Service Bulletin

NOVEMBER 1957 NO. 331

CARBURETOR AIR CHAMBER BASE -- 1957 GOLDEN HAWK AND PACKARD CLIPPER MODELS

Fig. 3
A. 20 Spline Rotor
B. 40 Spline Rotor

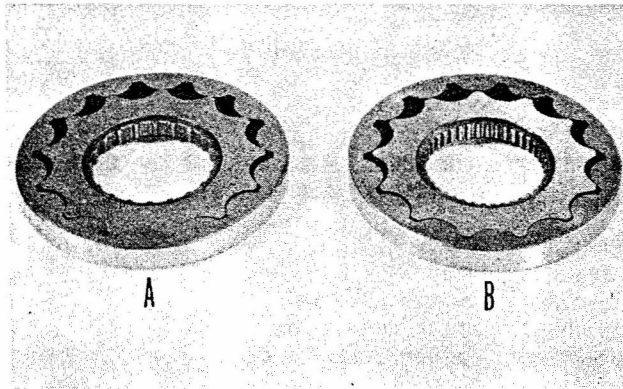
When the converter shaft assembly of the gear-start type Ultramatic transmission is replaced because of worn or stripped splines, it is advisable to check the front oil pump rotor. If the rotor is one having 20 teeth in the driving section, replace it with one having 40 teeth, Part No. 6489367. Whenever it is necessary to replace both the shaft and rotor, it is advisable to order either Part No. 6484523, Rotor and Shaft Kit, or Part No. 6484524, Pump Assembly and Shaft Kit. This will insure lon-

The front oil pump rotor ('A' in Fig. 3) having 20 internal splines is used in the 54th

Series Gear-Start, 55th and early 56th Series. 'B' shown in Fig. 3 is the 40 tooth splined rotor, Part No. 6489367.

56th Series production transmissions starting with serial numbers A-9681, B-6012, C-1143 D-1862 have front oil pumps with the direct clutch passage in the rear and have 40 tooth splines on the internal driving section. ("B" Figure 3).

Fig. 4
A. Direct Drive Clutch Oil Pressure Passage

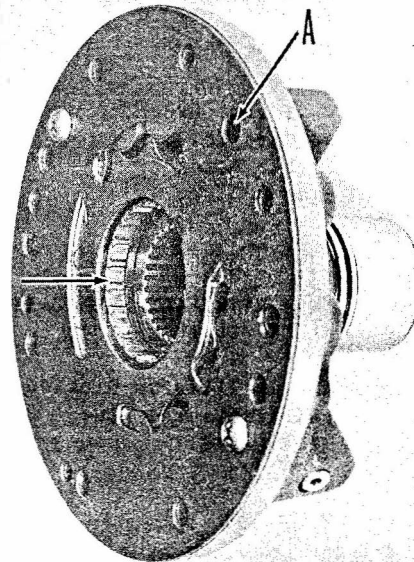
On the 54th Series Gear-Start, all 55th and early 56th Series Packard and Clipper models, the oil pressure for the direct drive clutch came out of a passage on the front side of the pump. See A, Fig. 4. The oil pressure was

directed through a passage in the bell housing then past the open splines in the rotor to the input shaft.

Fig. 5

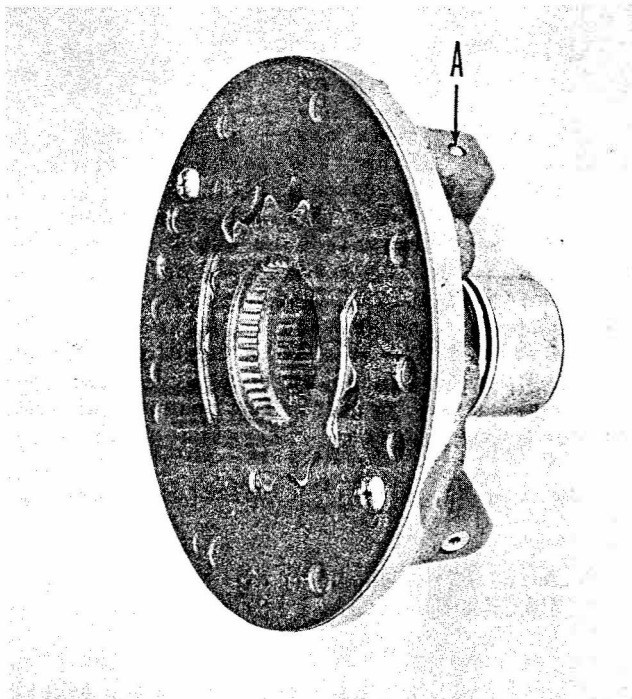
On the 56th Series Packard transmission after transmission serial number 5-40469, and all Studebaker 56J Golden Hawks, the front oil pumps have the direct drive clutch oil passage in the rear side of the pump. See at A in Fig. 5. The outlet for this passage is in between the two bushings inside the pump hub. Note that there is no oil passage in the front plate. However, this type pump originally had the 20 tooth splined rotor. (40 tooth shown in the illustration)

The 1/8" holes are not required in the converter shaft annular groove because the direct clutch oil passage is in the rear side of the pump body.

Fig. 6

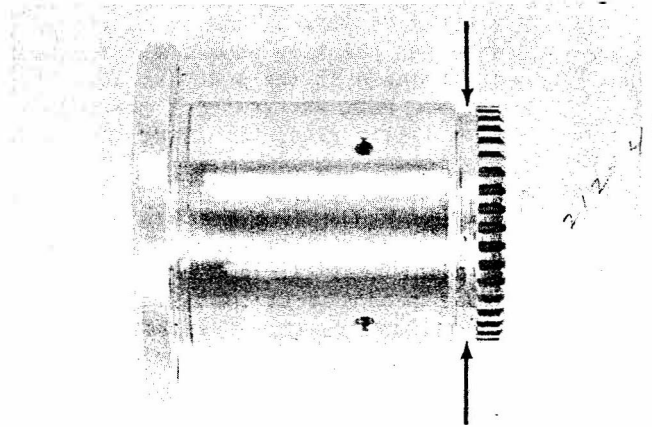
has 40 splines, therefore, it will be necessary to drill six 1/8" holes evenly spaced through the annular groove just back of the splines in the converter shaft to provide an oil passage to the direct drive clutch. "See arrows Fig. 6." This also applies when replacing the rotor assembly. When necessary to drill holes in the groove of the converter shaft, remove burrs from the edges of the 1/8" holes and internal bushing after drilling.

Fig. 7

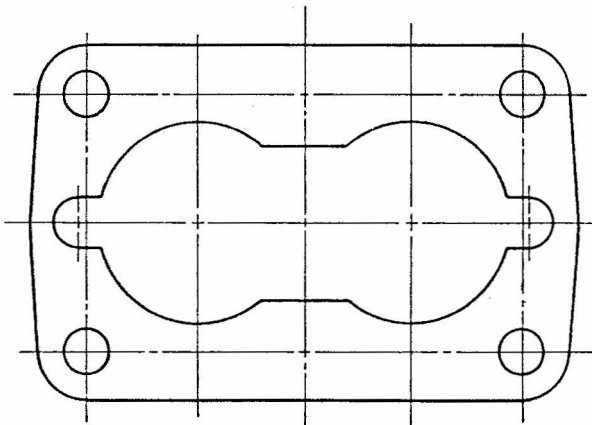
(a) It has been found that an improper gasket has been installed below the carburetor that either restricted or entirely cut off the vacuum to the vacuum-solenoid control assembly. With no vacuum acting on the control diaphragm, the downshift and throttle valves are held wide open. As a result, high control oil pressure and, high and rough upshift points will be experienced.

Carburetor Gasket, Part No. 1540006, (see Fig. 7) must be used with the Warner Gear Automatic Transmission.

Fig. 8

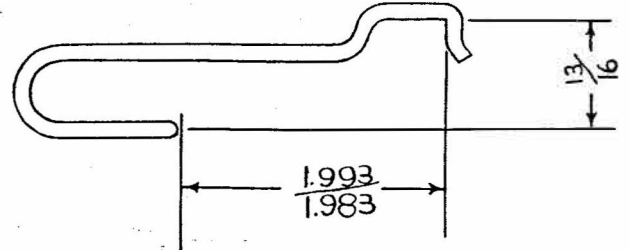
(b) Also check the Downshift and Throttle Valve Control Hook, Part No. 1687316, for distortion. Should this hook be distorted it will change the relative position of the downshift and throttle valves and thereby affect control pressure.

If the control hook has "opened-up" (see Fig. 8), it can allow the downshift valve to come out of its bore far enough to cock and not re-enter the bore correctly. When this happens the downshift and throttle valves will not respond to adjustments of the vacuum-solenoid control assembly and control pressure will be abnormally low.

To check for this condition, remove the vacuum-solenoid control assembly. Insert a length of 1/8" rod directly against the control hook rocker arm. Pressure against the rod should cause the downshift valve to move inward. If the rocker arm cannot be moved in this manner, it indicates the downshift valve is sticking. In this case, remove the control valve assembly and check the control hook, downshift valve, and throttle valve.
